**WHITE LAKE TOWNSHIP
INTER-OFFICE MEMORANDUM
COMMUNITY DEVELOPMENT DEPARTMENT**

SUBJECT: **Edendale Crossing**
Preliminary site plan approval
Rezoning request approval
Property described as parcel numbers 12-29-476-016 through 12-29-476-024, located northwest corner of Bogie Lake Road and Cedar Island Road, consisting of approximately 45.47 acres.

RE: Edendale Crossing- Preliminary Site Plan Review – 4th Review

**Preliminary Site Plan / Site Condominium / Planned Development Review
for
White Lake Charter Township, Michigan**

EXISTING ZONING PARALLEL PLAN: AG + R1-A

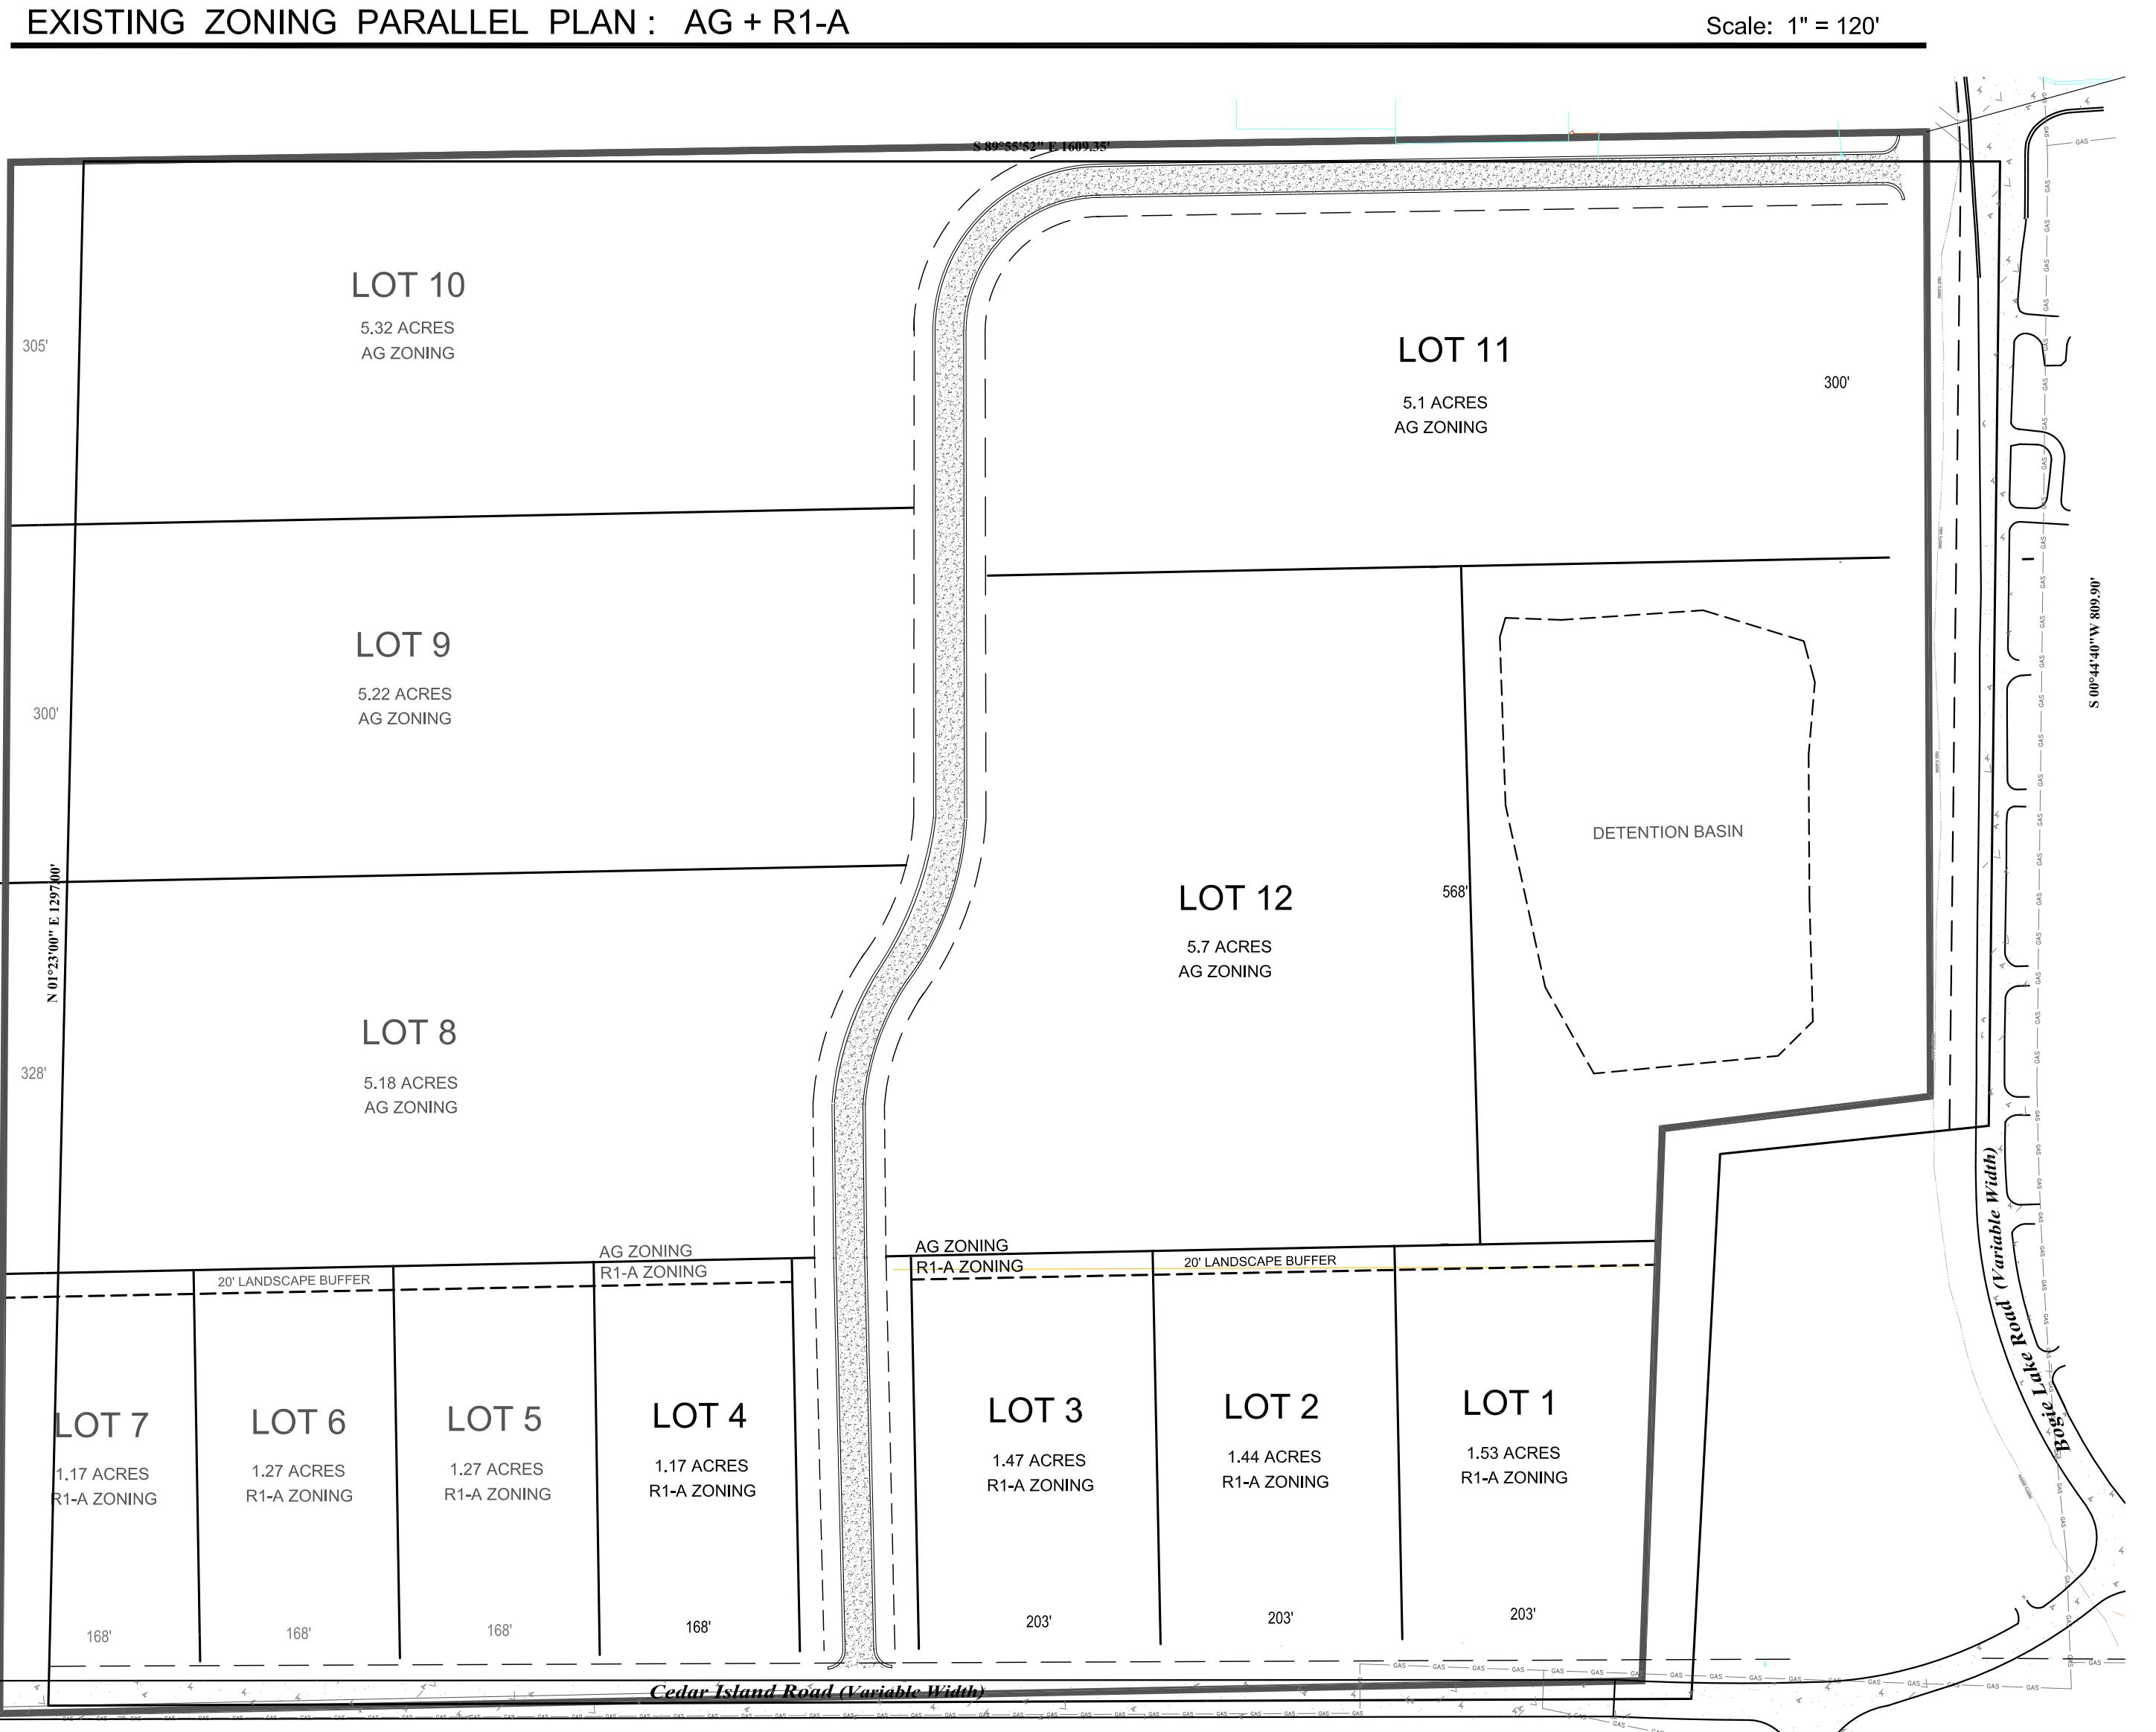
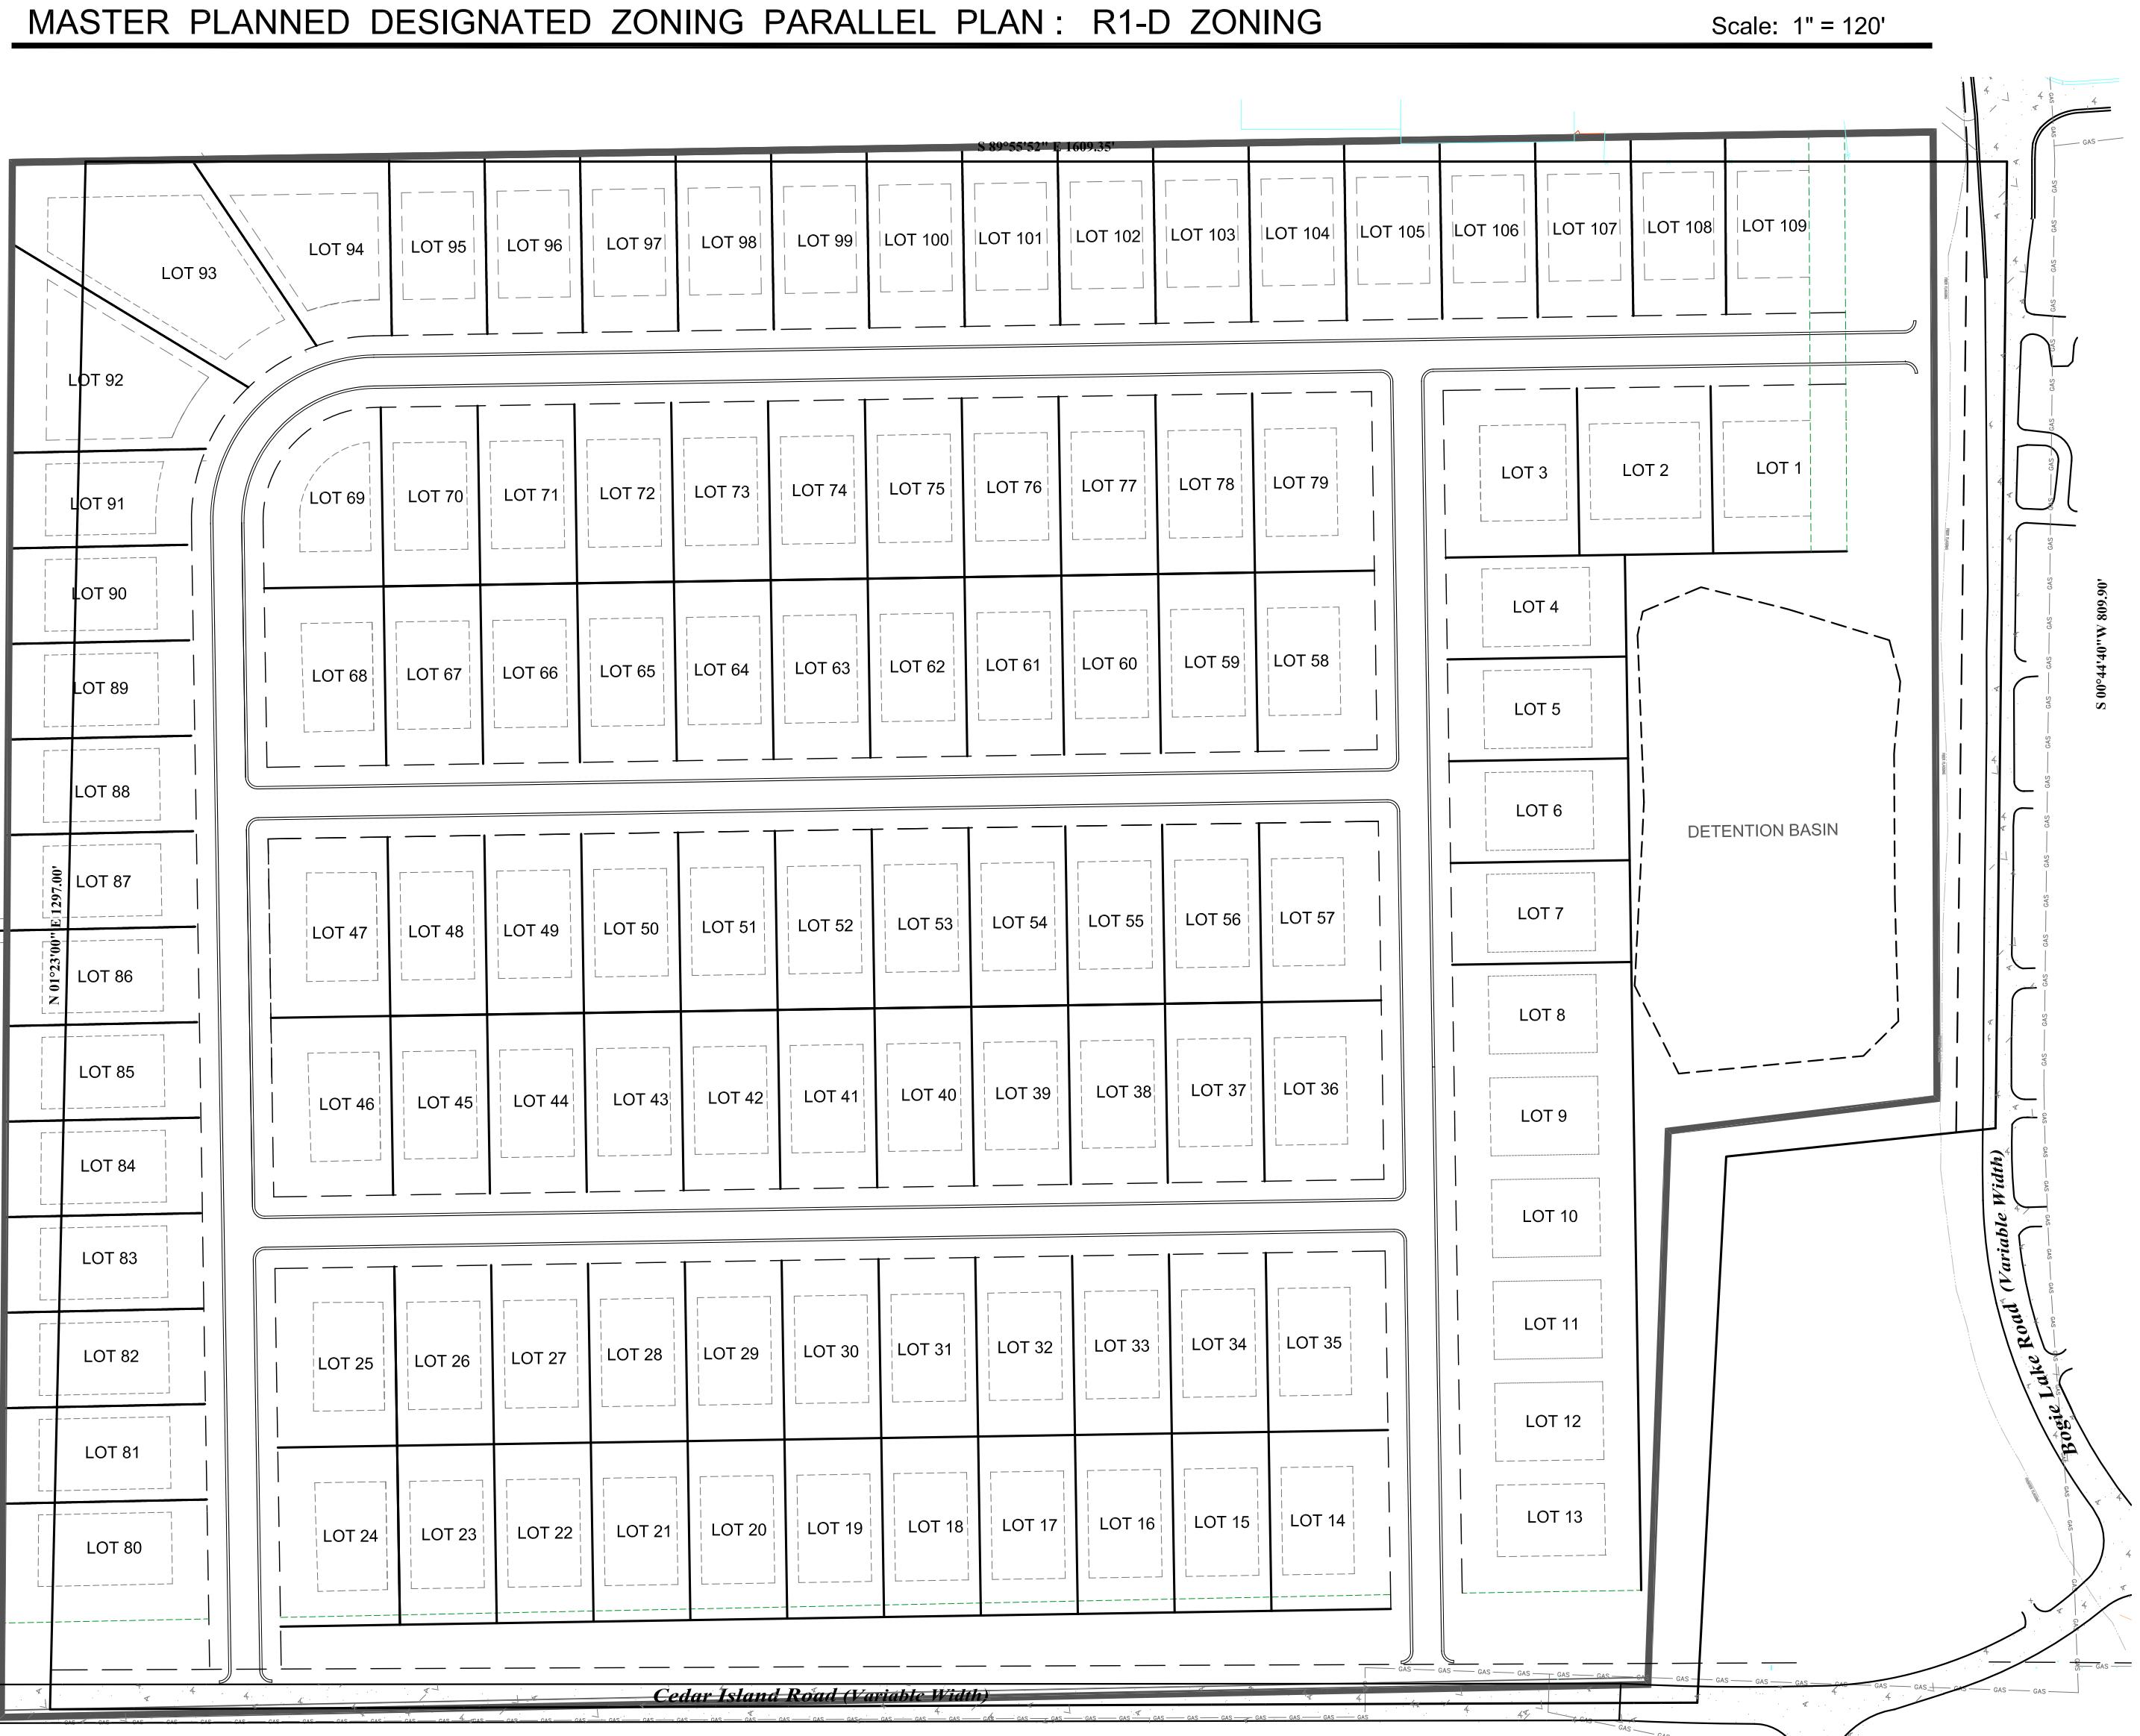
Sheet PSP-2 provides two parallel plans. One plan depicts the site developed under the current zoning (R1-A and AG). The other shows the site developed under the R1-D zoning which is the most comparable to the level of density proposed in the preliminary plan. Under current zoning, the site could be developed into 12 lots, each with a single family home. The site developed under R1-D would allow for 109 lots, each with a single family home. Per the lack of regulated wetlands, major natural features, and no requirement for open space in permitted by right R1-D and Condominium developments, the proposed development footprints of the two parallel plans are valid.

100 YEAR DETENTION BASIN CALCULATION (I.E. WITH OUTLET)

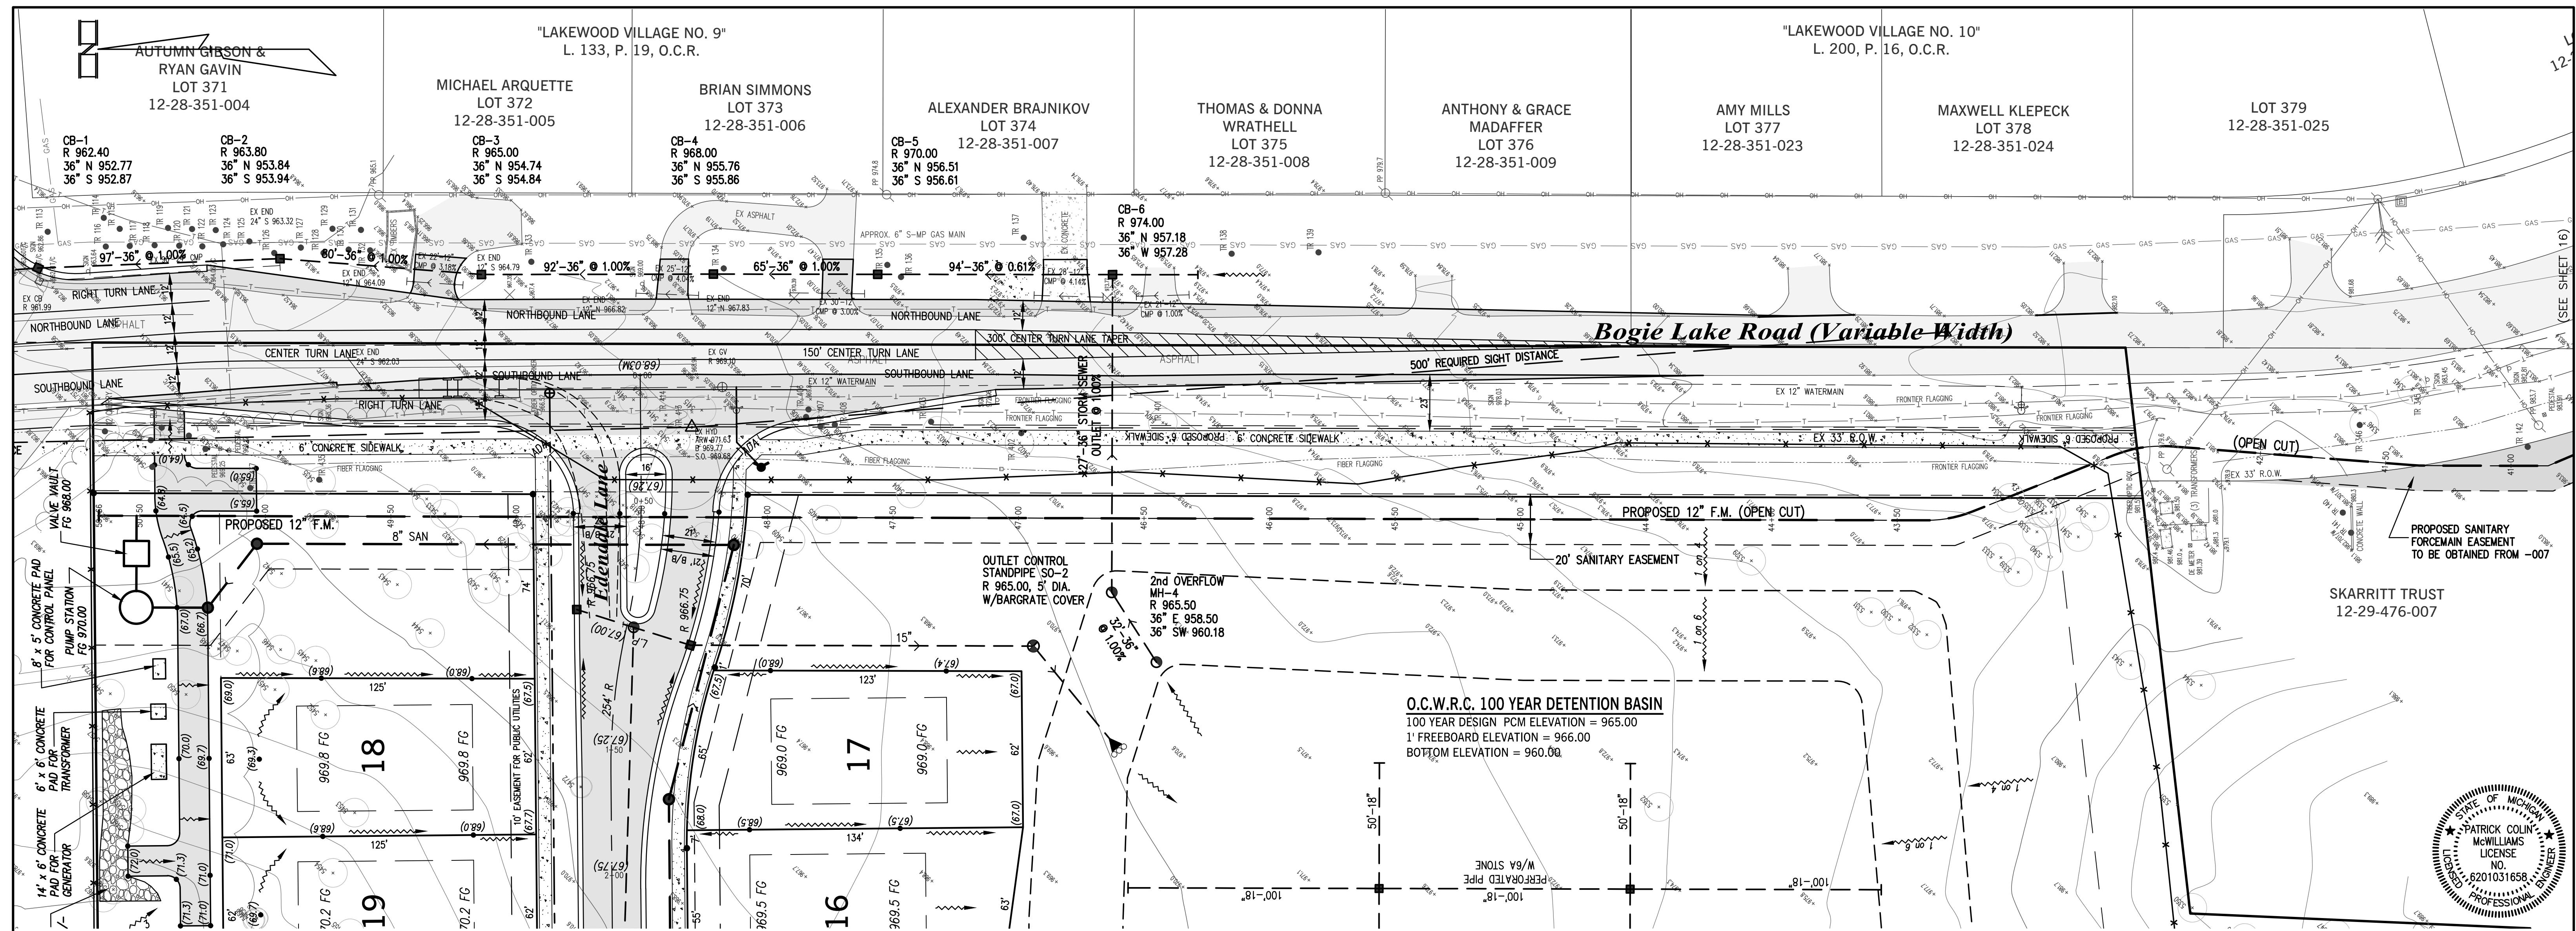
3. *There are several comments/questions we have regarding the Detention Basin Calculations and Details Sheet 16. We have attached a red lined copy of the sheet for the design engineer's use. **Comment partially addressed, but sufficient for this level of review. Please provide the T_t numbers in the 100 Year Basin Calculations. See attached plan sheet for a few remaining questions that can be answered with the FSP/FEP submittals.***
